11 Security-oriented mechanisms

11.2.5 Establishment of security mechanisms

Figure 11-1 Sequence of steps to establish secure ONU operation

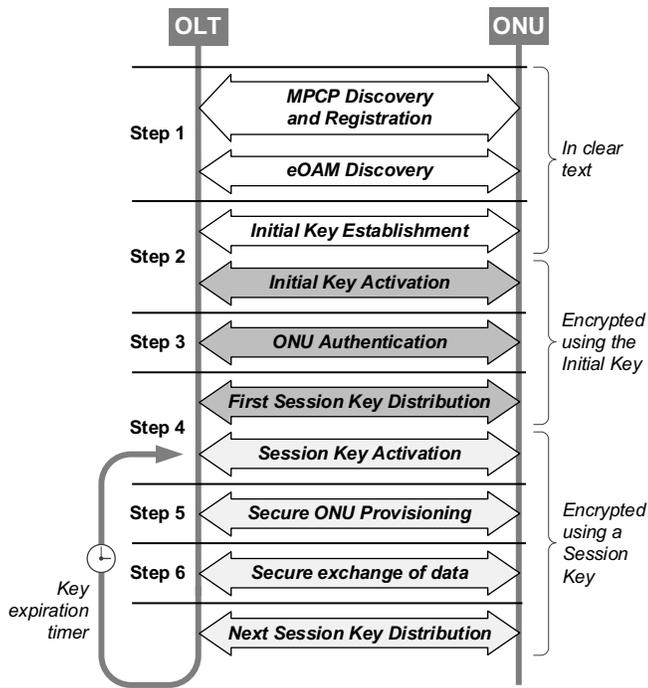
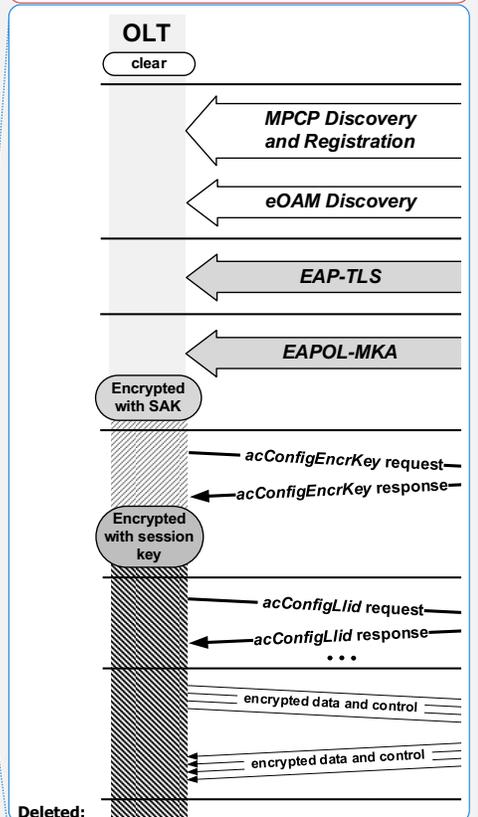
Deleted: Figure 11-2

- Deleted: [1.3]
- Field Code Changed
- Deleted: 2
- Deleted: -
- Deleted: ONU
- Deleted: successful discovery and registrati
- Deleted: n
- Deleted: s
- Deleted: . The OLT and the ONU employ

- Deleted: authentication
- Deleted: [1.4]
- Deleted: 11.3 to e
- Formatted: Highlight
- Deleted: session
- Deleted: If a trust store has been provisionedthe OLT has initialized a trust store on the ONU, the ONU additionally performs authentication of the OLT.

- Deleted: <#>Step 3 - Exchange Establishment of the initial Security Association Key: Once the ONU's identity is confirmed, the OLT and the ONU engage in an exchange of an initialkeying material used for mutual derivation of the initial cryptographic key used for secure communication. This exchange utilizes the E... [1]

The process of adding a new ONU to a PON follows a series of defined steps, ensuring secure ONU integration and subsequent operation. [Figure 11-1](#) illustrates these steps:

Step 1 - ONU Discovery and Registration: Upon completion of the boot/restart sequence, the ONU completes the MPCP and eOAM discovery processes as specified in [Figure 11-2](#). At this time, ONU gets assigned two logical links: PLID for exchanging the GATE and REPORT MPCPDUs and MLID for exchanging the OAM control messages (OAMPDUs). The MPCP and OAM discoveries are performed in the clear, i.e., using unencrypted MPCP and OAM messages.

Step 2 – Establishment of the initial key: Once the OLT and the ONU have established an MLID, they exchange keying material used for mutual derivation of an initial symmetric cryptographic key that enables private communication between the ONU and OLT and perfect forward secrecy (PFS). This is described in detail in [1].

Step 3 – Authentication: Upon establishment of the initial key, the ONU and OLT proceed with authentication using the method defined in [1]. This step ensures that the ONU is a trusted entity within the network and that the initial key is authentic.

Step 4 – Secure distribution and activation of session keys: The OLT/NMS distributes the new session key to the ONU using the session key distribution protocol (see [1]). The messages exchanged under the session key distribution protocol are encrypted using the initial key obtained in Step 2 above. After the encryption key is distributed to the ONU, the OLT initiates a switch to the new key (i.e., key activation by both the OLT and the ONU), using the procedure described in [1].

Step 5 – Secure provisioning of additional logical links: With the encryption of the PLID and MLID of the given ONU established, the NMS can proceed with provisioning of the additional bidirectional and unidirectional (multicast) logical links for this ONU. The additional logical links are provisioned using the extended action *acConfigLlid* (see [1]).
